HETCH HETCHY WATER TREATMENT PROJECT CHLORAMINE CONVERSION

Environmental Impact Report

Summary of Comments and Responses

Figure IV.C-1 (Revised)
Pulgas Dechloramination Facility Vegetation
Communities and Prominent Natural Features

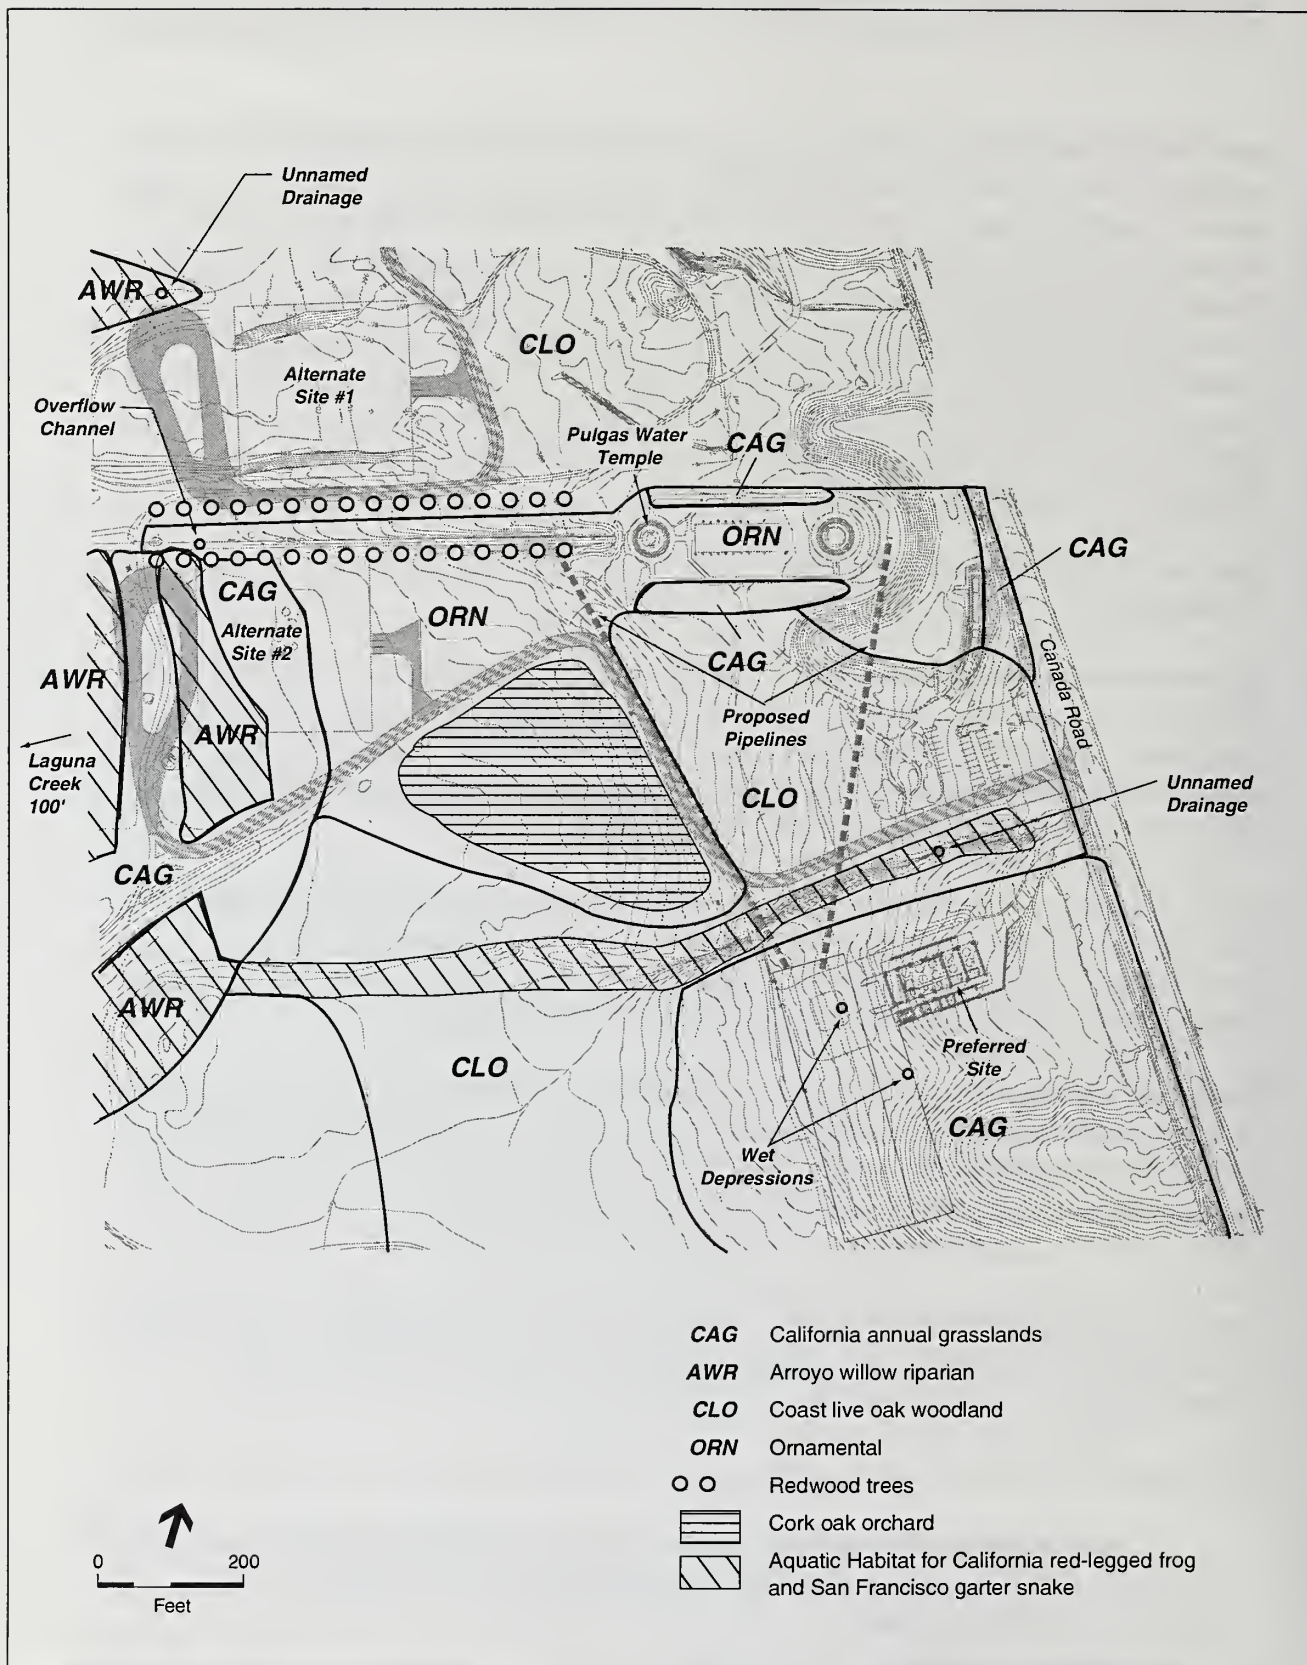
Comment F-3: “Page IV.C-20, paragraph 3. Suggest showing the snake and frog habitat on a map. Clarify the location of the ‘overflow channel work area.’ The sentences beginning with ‘Grasslands adjacent...’ and ‘While observed near the site...’ seem contradictory, please explain.” (United States Department of the Interior, National Park Service, Golden Gate National Recreation Area)

Response: The comment concerns the quality of grasslands habitat at the Pulgas site for supporting California red-legged frog. The seasonally moist willow-riparian habitats identified near the Pulgas site provide upland habitat and potential breeding habitat for both California red-legged frog and San Francisco garter snake. Ephemeral water is available at both willow habitat areas. California red-legged frogs are known to migrate through habitats near breeding pools in search of summer habitat, and may aestivate within grasslands if suitable cover is available. The grasslands at the Pulgas site, as described in DEIR Section IV.C, Biological Resources, refer

specifically to that portion of the project footprint that is covered by grasslands, and apply to the proposed location of the dechlorination facility. While some grasslands in the project vicinity provide excellent habitat for both San Francisco garter snake and California red-legged frog, a thorough survey of the project site did not identify habitat components required by California red-legged frog in the subject grassland. The grasslands in question were generally devoid of burrows, cover (such as woody debris), and topographic features that would provide aestivation or concealment for California red-legged frog. It cannot be ruled out that frogs could seasonally migrate across the site, and it should be clarified that the California red-legged frog is not expected to use the annual grassland portion of the Pulgas site as upland aestivation habitat because of the generally poor cover this area provides.

In response to this comment, DEIR page IV.C-8, Figure IV.C-1 has been revised, as shown on the following page.
